### **REMARKS**

**Amendments to the Drawings:**

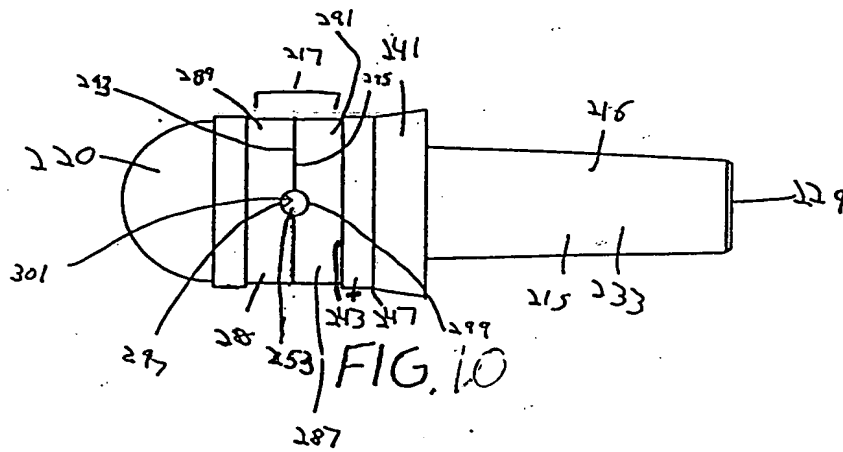
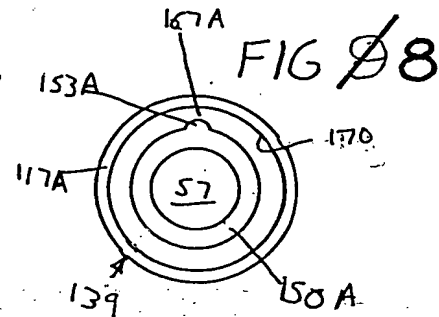
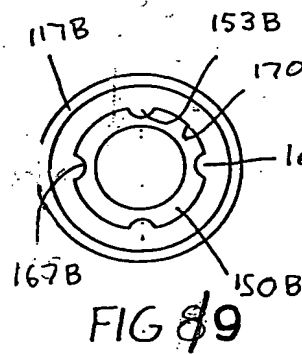
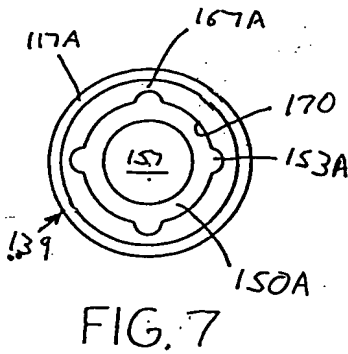
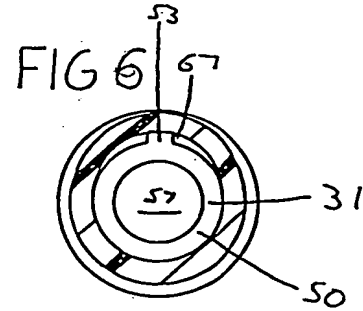
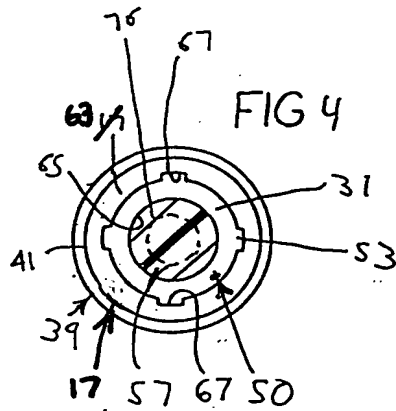
The Examiner objected (Action, Para's 3, 4, 5, and 6) to the drawings for reasons given. First the Examiner objected to the reference characters "16" and "50" and their designation. Second, the Examiner objected to the numbers of FIGS. 8 and 9 as being incorrect.

By this Reply, FIGS. 1, 2 and 3 and the Specification are amended in a manner to clarify the elements "16" and "50" and the use of the terms rearward end portion, rearward leg, first leg, forward end portion, forward leg, and first leg.

FIG. 1: delete the arrowhead on the leadline for “16”, add an arrowhead at the end of the leadline for “17”; and clarify the exterior contour “69” and “71” of the driving band “17”.

FIG. 2: change the numbers “16” and “15” to read “15” and “16”; change the number “74” to read “57” for the forward cavity in the leg “50” of the projectile body “11”; add the number “74” and a lead line pointing therefrom to a chamber in the insert member “19”; add the number “21” and a leadline pointing therefrom to the dome shaped wall of the nose “20”; add the number “25 and a leadline pointing therefrom to the interior surface of the nose “20”; delete the number “24” and the leadline therefor; and add the number “23” and a leadline pointing therefrom to a cylindrical annular surface of the interior wall “25” circumjacent to the open end of the nose “20”.

FIG. 3: change the numbers “16” and “15” to read “15” and “16”; place an arrowhead at the end of the leadlines from “17” and “19”; shorten the end of the leadline from “54”; and delete the number “74” and the leadline therefore.

FIG. 4: replace the number “17” with “63”; add a number “17” and a leadline pointing therefrom to the drive band; shorten the leadline from “41” to point to the tapered surface; and shorten the leadline pointing to the forward leg “50” and end the leadline with an arrowhead.
